# Access Compliance Report

## Public Rights-of-Way

Intersection ID: N/A	Main Street: YORK_CENTER	Cross Street: N/A	Location: NW
ADA ID: 29EAF73E4055	Ramp Type: Para	Initial Pass/Fail: Fail	Overall Compliance: No
		Severity Score: 12.5

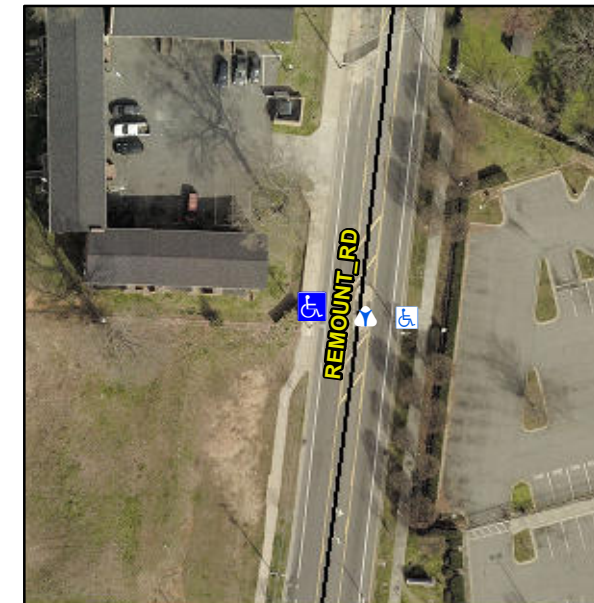
**R304.3.2**

Compliance	Description	Data	Compliance	Description	Data
N/A	Ramp Length LT (in)	49.0	N/A	Ramp Length RT (in)	132.0
Yes	Ramp Width LT (in)	89.0	Yes	Ramp Width RT (in)	88.0
No	Ramp Slope LT (%)	8.7	Yes	Ramp Slope RT (%)	8.0
Yes	Ramp XSlope LT (%)	1.4	Yes	Ramp XSlope RT (%)	1.4
N/A	Landing Length (in)	N/A	N/A	DWS Provided?	N/A
N/A	Landing Width (in)	N/A	N/A	DWS Contrast?	N/A
N/A	Landing Slope (%)	N/A	N/A	DWS Length (in)	N/A
N/A	Landing X Slope (%)	N/A	N/A	DWS Full Width?	N/A
N/A	Landing Curb? (Y/N)	N/A	N/A	DWS Offset (in)	N/A
N/A	Shared Landing?	N/A			
N/A	Gutter Ponding?	N/A	N/A	Gutter Slope (%)	N/A
N/A	Gutter Lip Ht (in)	N/A	N/A	Gutter X Slope (%)	N/A
N/A	Painted X Walk1?	No	N/A	Painted X Walk2?	N/A
	X Walk 1 Direction	To E		X Walk 2 Direction	N/A
N/A	X Walk 1 Width (in)	N/A	N/A	X Walk 2 Width (in)	N/A
	X Walk 1 Slope (%)	7.3		X Walk 2 Slope (%)	N/A
	X Walk 1 X Slope (%)	3.5		X Walk 2 X Slope (%)	N/A
N/A	Ramp inside XWalk1?	N/A	N/A	Ramp inside XWalk2?	N/A

**Remove & Replace Entire Ramp.**
